Model: Pomelo	Date: 30-Apr-99	No.: RG033001a
---------------	-----------------	----------------

RTB Correction

Subject: Detailed Self -diagnostics Error		Prepared by: H. Someya	
From: Technical Service Dept., GTS Division			
Classification:	<input checked="" type="checkbox"/> Troubleshooting	<input type="checkbox"/> Part information	<input type="checkbox"/> Action required
	<input type="checkbox"/> Mechanical	<input type="checkbox"/> Electrical	<input type="checkbox"/> Service manual revision
	<input type="checkbox"/> Paper path	<input type="checkbox"/> Transmit/receive	<input type="checkbox"/> Retrofit information
	<input type="checkbox"/> Other ()

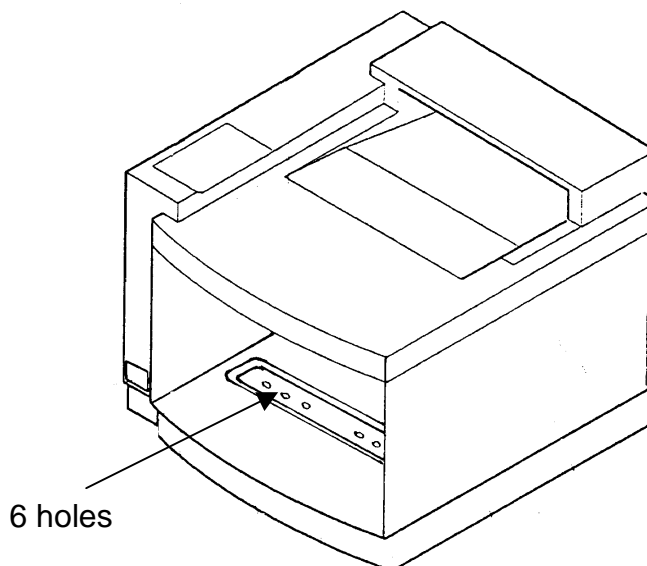
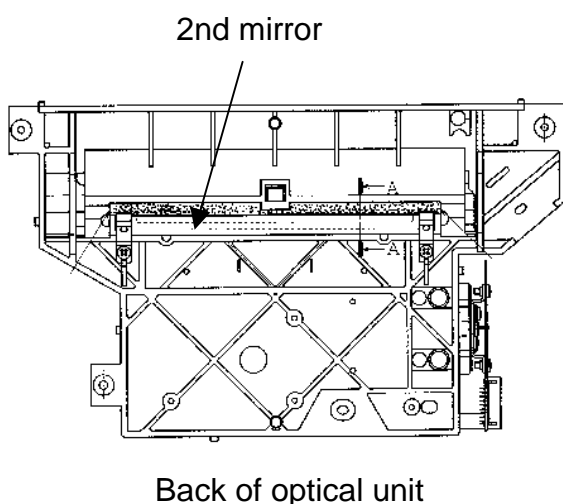
- Uneven or faint image
- SC41 appears.

Dust entering from the holes in the base adheres to the 2nd mirror over time.

1. Remove the optical unit and clean the 2nd mirror with an optical cloth.
2. Use tape to block the 6 holes in the base.
3. Reassemble the machine.

Polyester tape has been attached to block the 6 holes in the base (effective as of February production runs).

Diagram 1

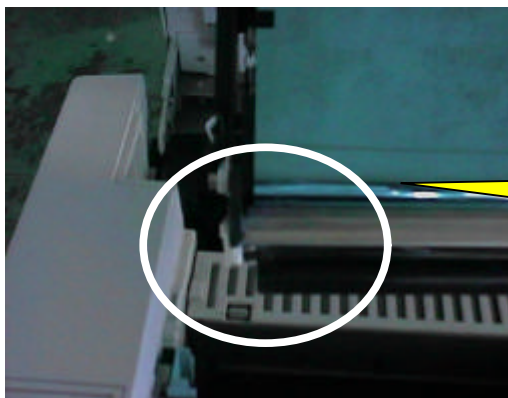
1. Remove the belt cartridge.
2. Measure the gap L between side plate and OPC belt as shown in diagram 1.
3. Do one of the following actions depending the length of gap L:

Gap L (mm)	Required action
0 – 3	Attach one spacer to the bearing on side A as shown in diagrams 2 & 3.
3 – 7	No action necessary
7 - 10	Attach one spacer on the bearing on side B as shown in diagrams 2 & 3.

4. Install the belt cartridge and the turn on the machine.
5. Measure gap L after the machine has finished warming up.
6. If gap L is 3 mm to 7 mm, this procedure is complete. If gap L is less than 3 mm or more than 7 mm, repeat this procedure from step 3 (attach one more spacer).

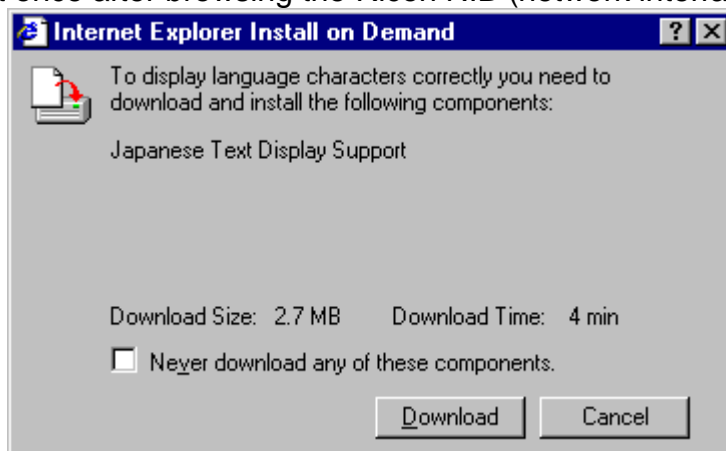
i.e., if browsing http://Printer IP Address/en/cgi-bin/sts_index.cgi, the following message appears:

Maybe the message is different because of a minor variation in the IE version or Windows OS. The above message appears when using IE 5.00.2920.0000 with Windows 2000. In this case, IE requires a Japanese font every time.

IE 5.00.2314.10003 with Windows NT 4.0 is shown below. In this case, IE requires a Japanese font once after browsing the Ricoh NIB (network interface board).

If the NIB version is 3.8.7 or earlier, please get the latest Ricoh NIB firmware and install the new one in the NIB.

Install a Japanese font in Windows. There are a few ways to install Japanese fonts.
